## Flood Consultant Response to EA Letter

Our ref: WA/2021/129495/02-L01  
Your ref: 211739

### Demolition of the existing buildings and the erection of 9 new houses with associated parking and landscaping

#### 2-4 Send Road, Caversham, Reading, RG4 8EH

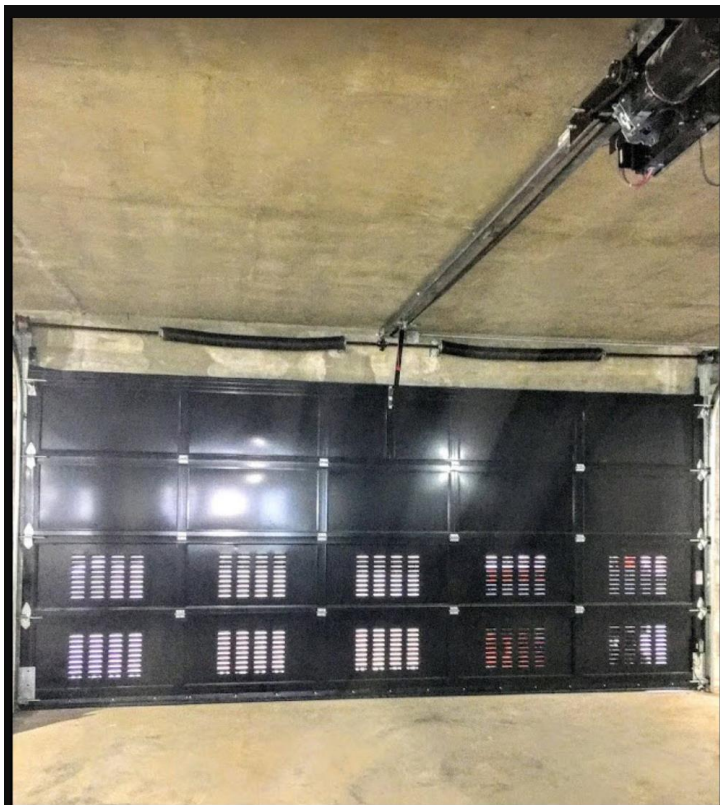
Further, we are concerned with the use of garages in the void design. Garage doors appear to provide void openings to the west of the development site, in accordance with the Proposed Foundation Plan GA drawing (number SR\_P\_086, revision P05, dated 7 March 2022). Garage doors would block flood flows, and therefore are clearly not appropriate as void openings. In addition, we do not identify new garages as being suitable for flood storage areas. Land to be utilised as flood storage during a flood event must remain open and free of any obstruction. Therefore, proposed garages should be included as part of the

proposed built footprint.

The garages are not part of the house as there is no direct access from the garages to the house.

The garages are purely a space to park a car that also happens to have a roof over it which forms the 1<sup>st</sup> floor of the dwellings.

The EA never allows garages to be used as footprint in flood compensation calculations so it follows that these garages are not footprint and would allow flood waters to flood into the garage and flow under / through the house as part of the void flow pathways.

Cars parked on the site, not in garages would perform the same in terms of flooding.

Garage doors are not waterproofed / watertight and generally the EA has always considered that the water would enter garages as if they were not present.

In order to provide additional confidence and as a practical approach, the garage doors will have louvres similar to the specification below. These will be integrated and hence unlike flaps etc will not be obstructed, cannot be used to gain unlawful entry and would not be tempting to alter.

The louvres can provide suitable flood entry openings to higher than the worse case design flood level.

CLIENT  
RAYWOOD DEVELOPLMENTS LTD  
PROJECT  
2-4 SEND ROAD  
CAVERSHAM, READING  
DRAWING TITLE  
PROPOSED FLANK ELEVATIONS

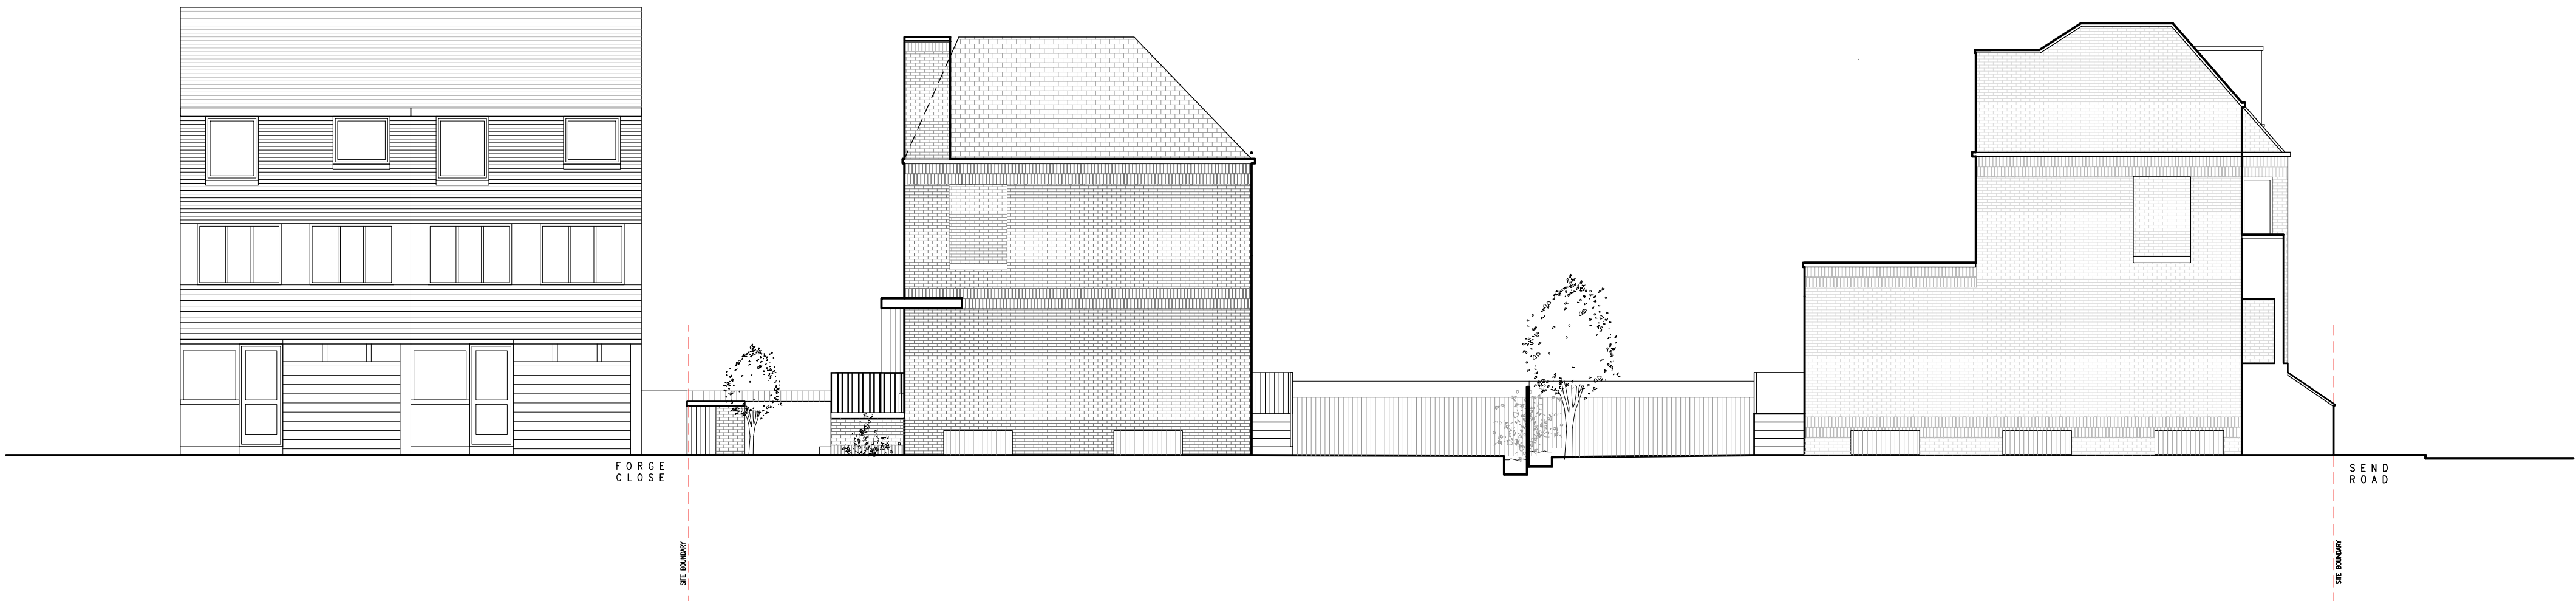
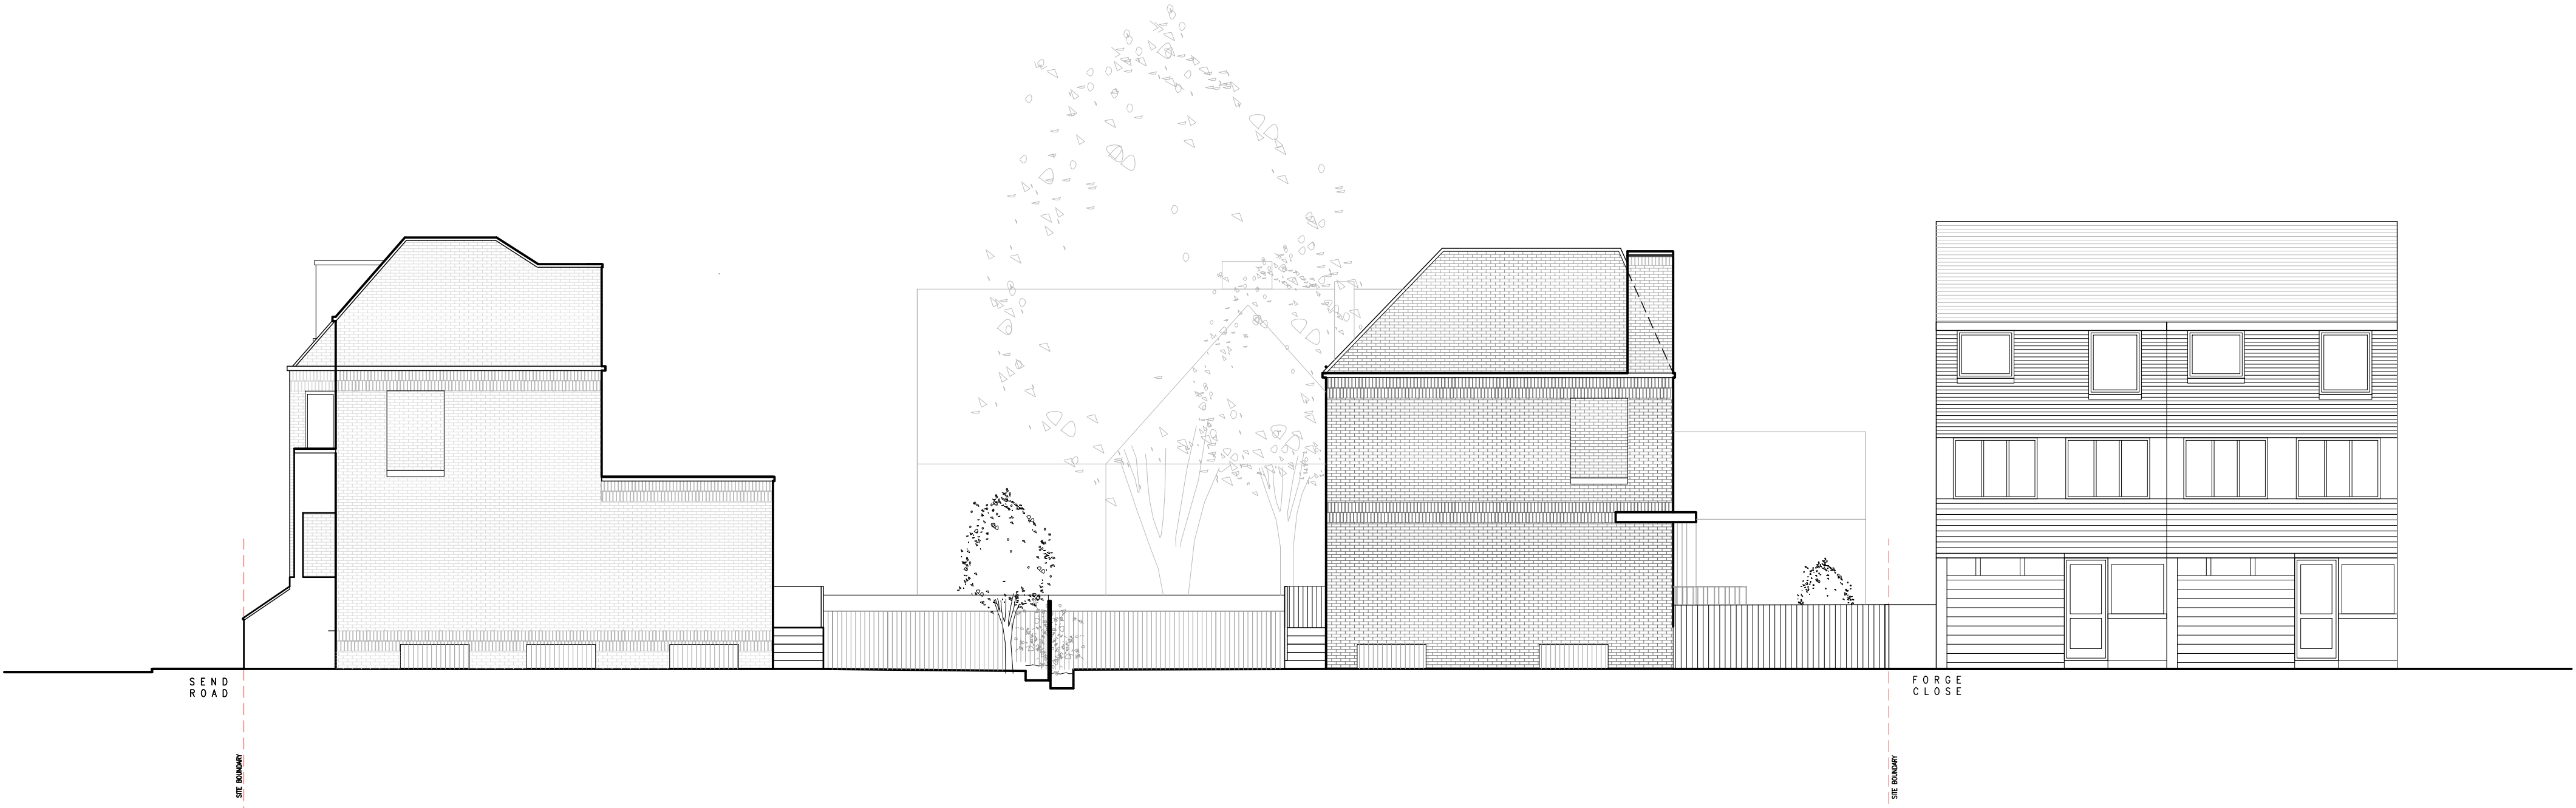
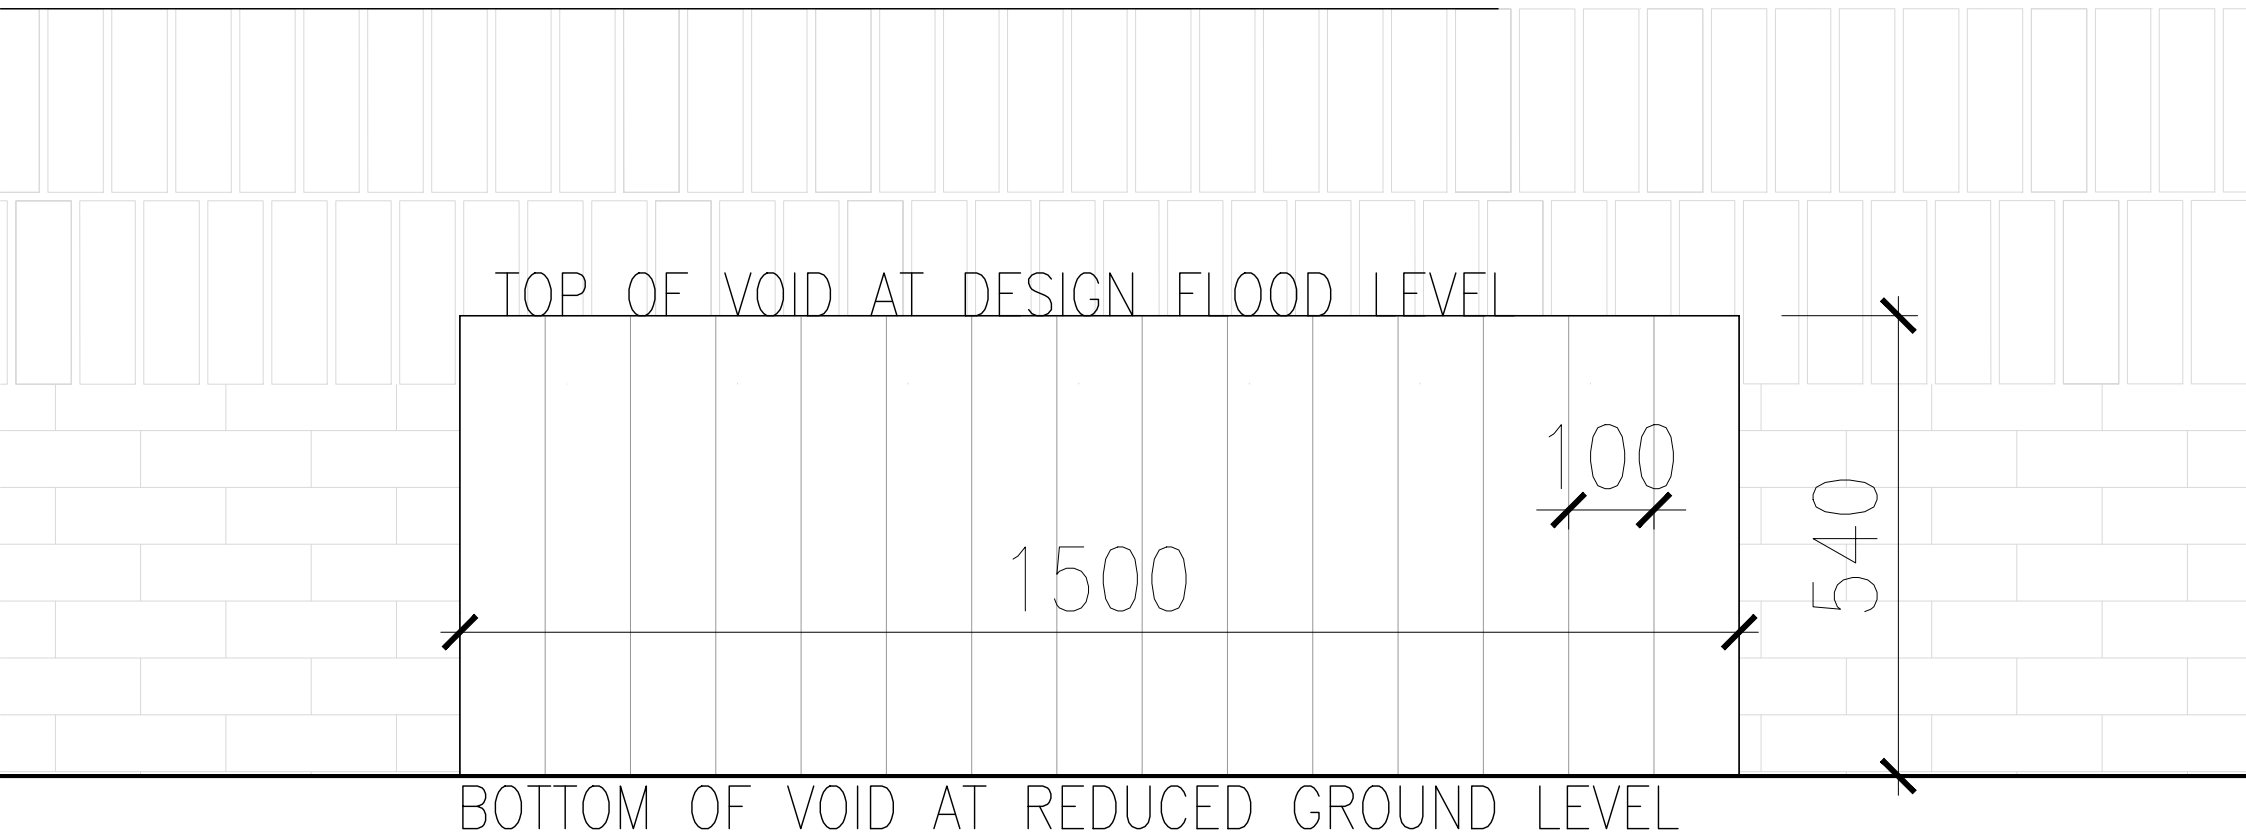
We are not satisfied with the design of the void spaces and openings. The letter from Ark Environmental states 'The scheme has not changed from the application submission'. Therefore, our earlier concerns in relation to void design have not been overcome. From the Proposed Foundation Plan GA drawing, it appears that void openings have still not been provided on all sides of the proposed buildings (please note that void openings should be clearly labelled and not inferred from a plan). In particular there are no openings on the sides of the buildings to the north and south, or between the terraced dwellings, which would prevent the free flow of flood waters. As it has not been demonstrated that flood waters can freely enter and leave the void spaces, the proposed development is likely to obstruct flood flows, which could result in an increase in flood risk elsewhere contrary to national policy.

**Resolved: We have included voids on all elevations now. The drawings have been updated accordingly.**

**All void openings are greater than 1.0m in width and their opening is from existing ground level up to a minimum of the agreed design flood level.**

**See Appendix B for the revised foundation layout with voids on all elevations and each void dimensions provided.**

**See Appendix B also for a typical void dimension sketch.**

**See Appendix B with the updated elevation drawings to show the voids on the north and south elevations.**

| REV | DATE     | DESCRIPTION                              | DRAWN BY |
|-----|----------|------------------------------------------|----------|
| P03 | 17.06.22 | FLOOD VIDS ADDED TO THE FLANK ELEVATIONS | DG       |
